**ZONING MAP CHANGE
STAFF REPORT**

City Council Meeting Date:
June 14, 2016

Proposed Use: Required Site Plan for PD 916 multifamily development

Companion Cases: ZC-15-148/PD-916

SITE PLAN

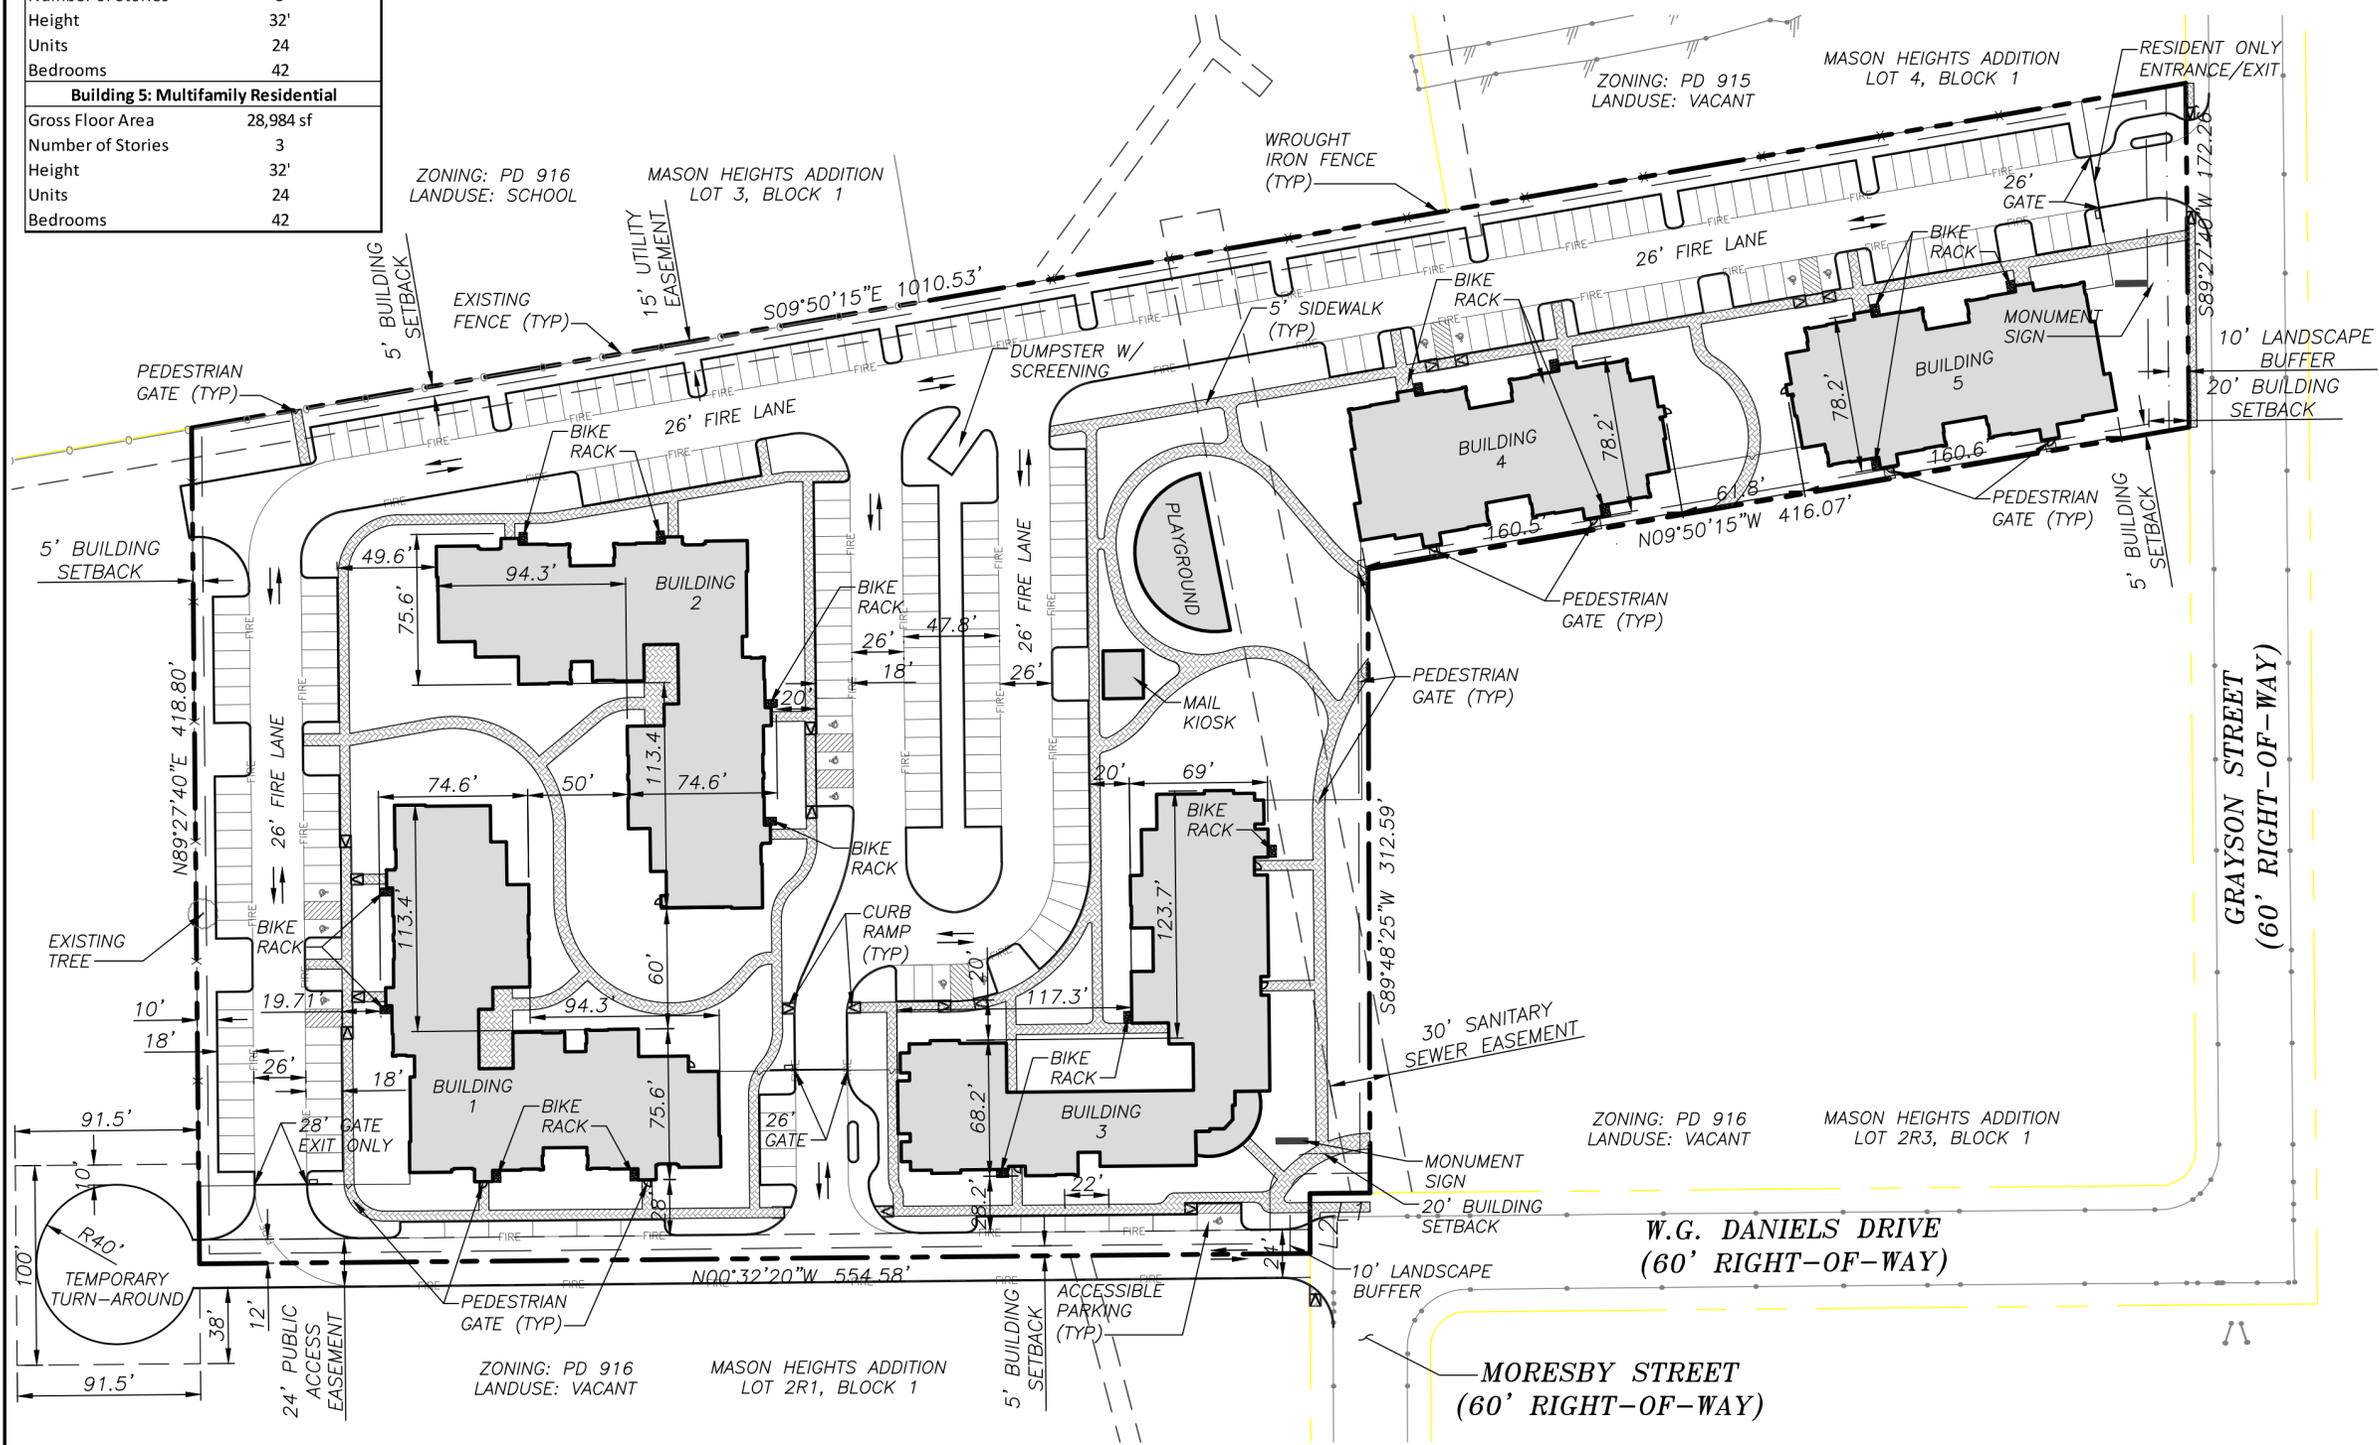
1. Subdivisions containing more than thirty (30) one-family or two-family dwelling units shall have a platted and constructed secondary ingress and egress to a public street. Multi-family developments of 100 dwelling units or more shall have a platted and constructed secondary ingress and egress to a public street.

2. Emergency access easements shall not be less than 26’ in width. Show the full 26’ width on the plat. Where emergency access easements intersect, the dedication of a 10’ by 10’ public open space easement (POSE) shall be dedicated for sight visibility shall be required. The emergency access easements shall remain unobstructed at all times. The access easement north of W. G. Daniels is required to be 26 ft. as the project is a multifamily development.

3. Gated entrances into secured areas must be designed in accordance with TPW’s “Traffic Engineering Design Standards and Policy Guidelines”. Provisions for an acceptable turnaround must be made. Provide details in IPRC plan set (single-family) or UR site plan (multi-family) for gates. All gates shall be equipped with a knock-box or other approved fire access apparatus that is reviewed and approved by the Fire Department. (Gates must be located 3 vehicle lengths from the ROW). Two driveways are required to be full ingress/egress access points to the development with the required three vehicle stacking from the right-of-way. As shown, the site plan only has one gate that complies with the vehicle stacking requirements.

4. On street parking may be permitted within city right-of-way with approval of design and location by TPW. On-street parking is not guaranteed nor can it be reserved for a specific site. TPW recommends that on-street parking provided not be counted towards minimum parking requirements because it is available for the public in general.

5. Sidewalks and street lights are required for all public and private streets and public access easements as per City of Fort Worth Standards.
